Date of Issuance: 1/14/2025	Effective Date: 5/21/2025
Owner: Panama City, FL	Owner's Contract No.: PC25-033
Contractor: Mainline Construction	Contractor's Project No.: 2025-11
Engineer: Barge Design Solutions	Engineer's Project No.: 37711-15
Project: SRF Project Area D-14	Contract Name:

WORK CHANGE DIRECTIVE NO.: 1

Re: SRF Area D-14 : Change Order Request for 6" Laterals

Re: Work Change Directive #2 Request – Additional Tree Removal

## EXHIBIT B

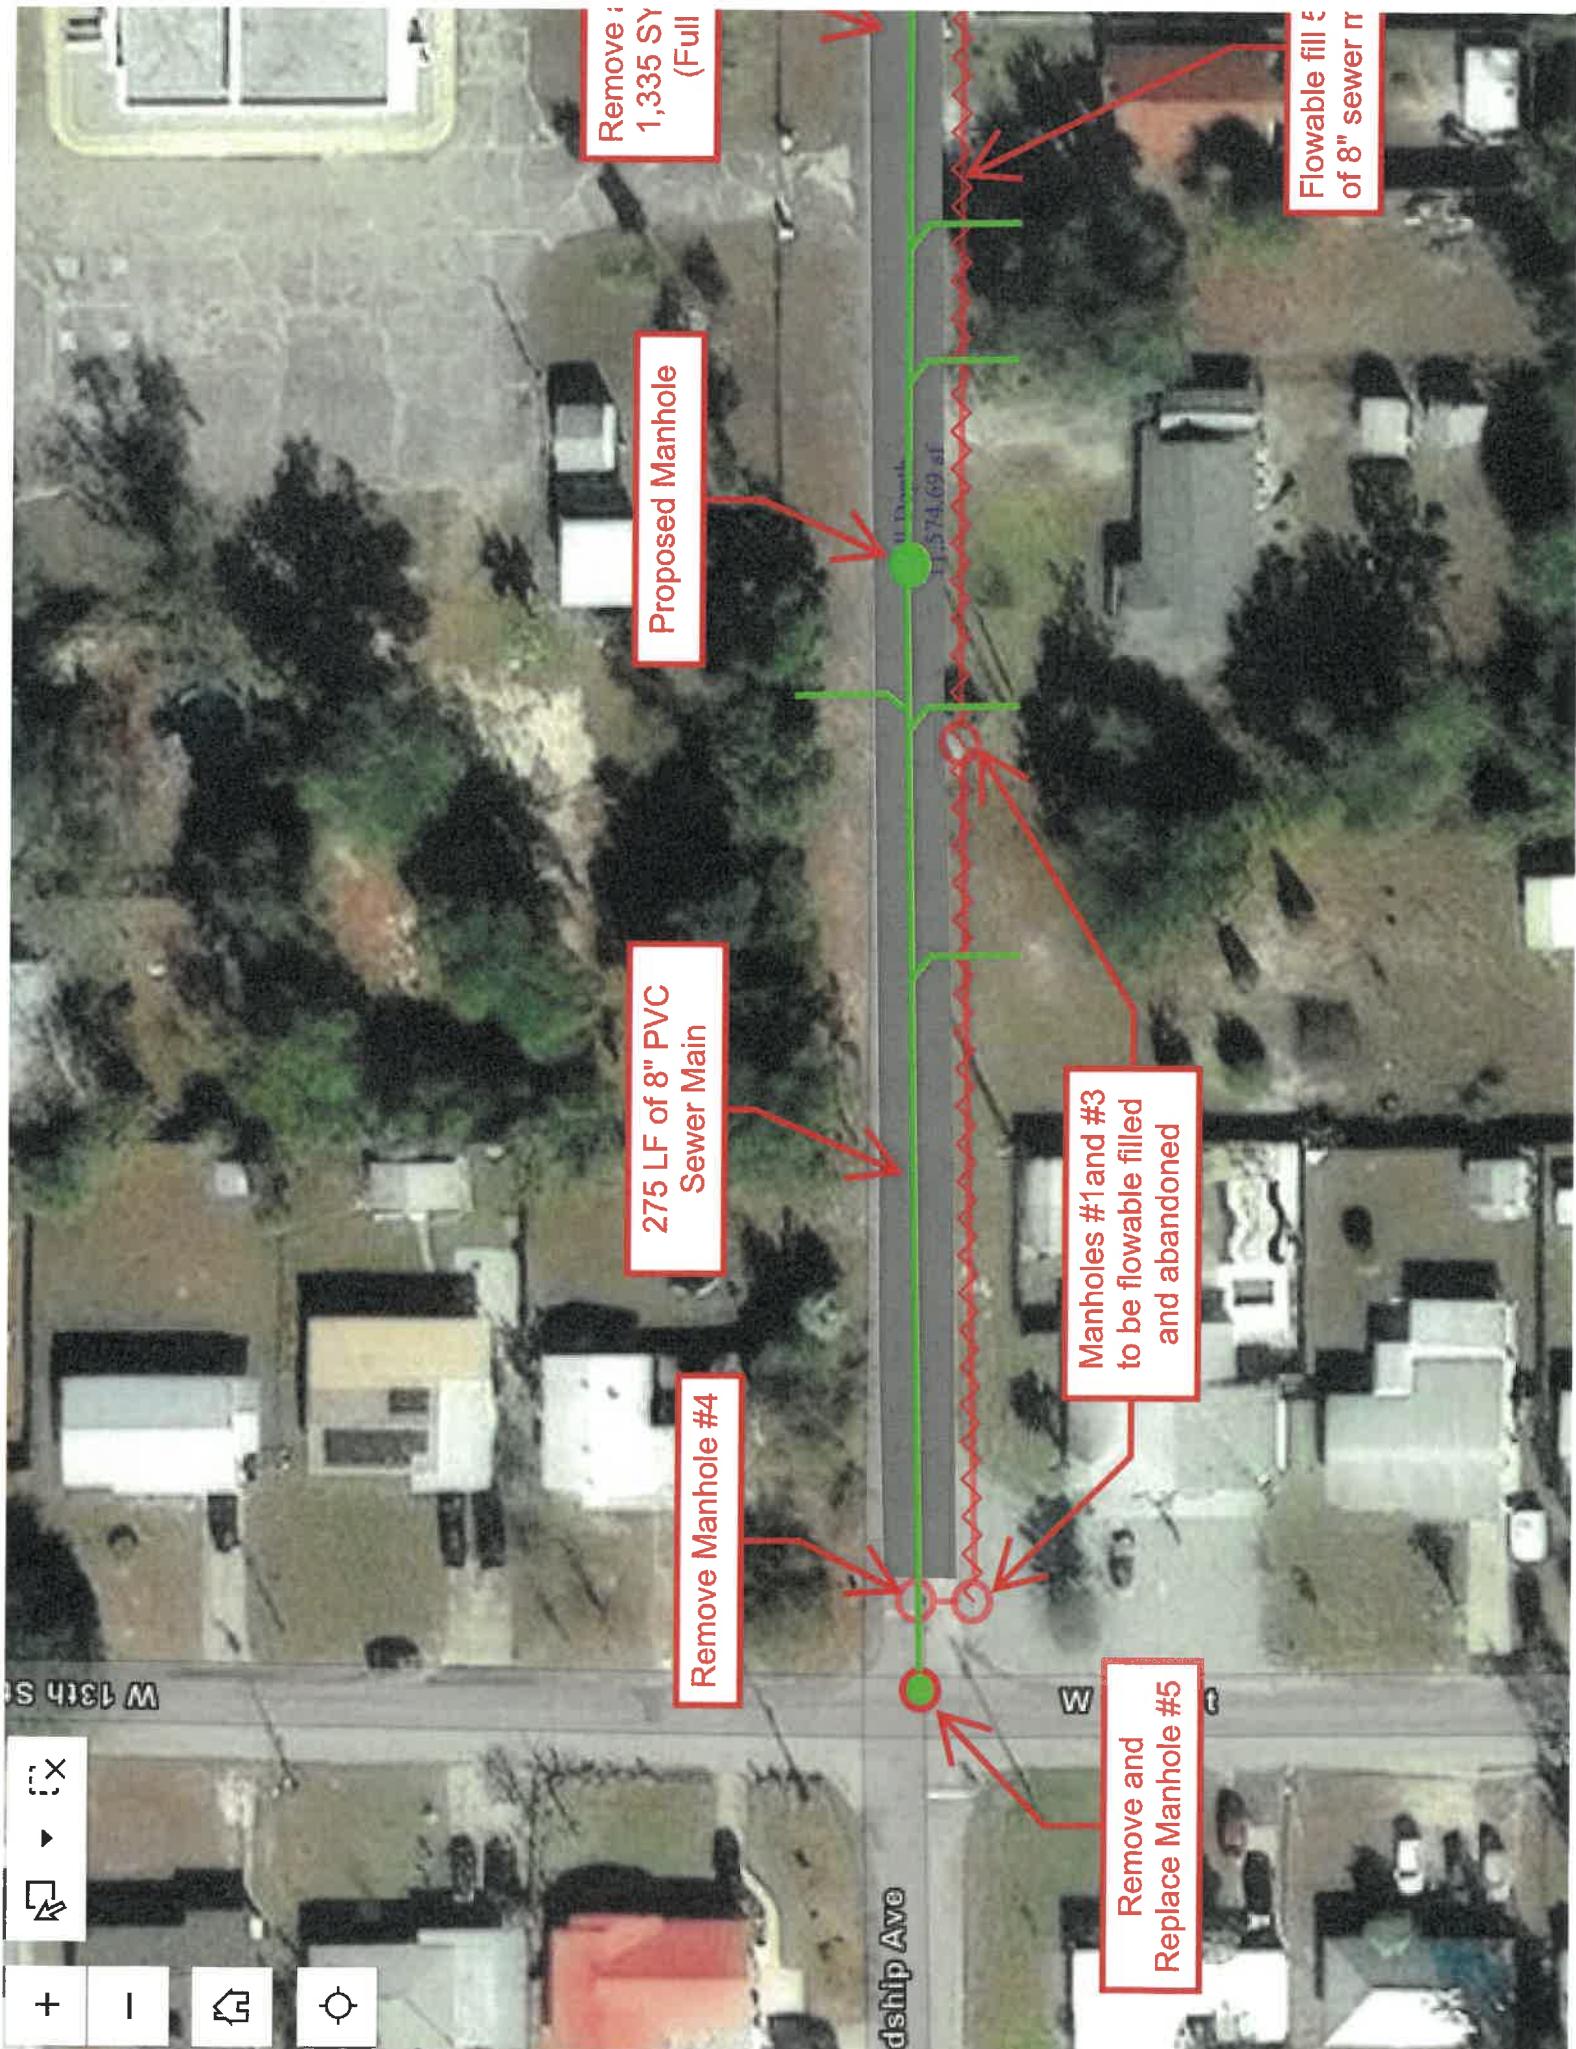
Scope of work: Per the discussions on site, Mainline proposes to remove and haul off of (1) popcorn tree and (1) oak tree that are in conflict of installing the proposed sewer main. See overview for the locations of these trees.

1. Mainline requests for this work change directive to be approved as soon as possible.
2. The lump sum price includes removal of the trees, stumps and haul off of both trees. The popcorn tree will be cut off flush at the top of the existing fence.
